Another great step forward:  
**A NEW VALVE FROM BAUER –  
AND YOU CAN UPGRADE!**

## OUR NEW VALVES ...

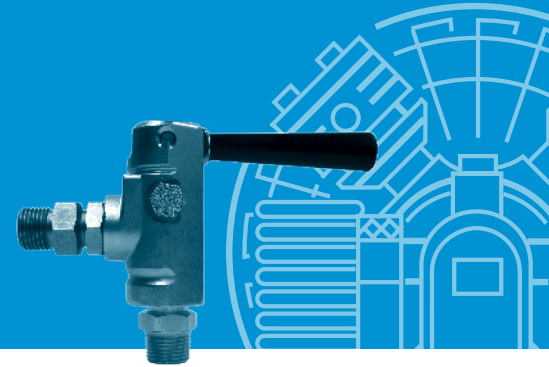
Our filling valves have proved themselves in service unchanged for many years. Now we have developed their design further.

In this connection the valve has been equipped with a noise-reduced pressure-relief feature.

- With the pressure-relief feature noise is reduced by more than half (16 dba).
- More-pleasant, deep frequency of the blow-off tone tuned to the human ear!
- In addition, the low residual noise and the surplus air can be discharged outside by means of a G1/8 connection!
- Fully downward compatible and replaceable everywhere!
- Many individual parts can be purchased separately – which saves costs!
- Maintenance kits available, which assures continuity
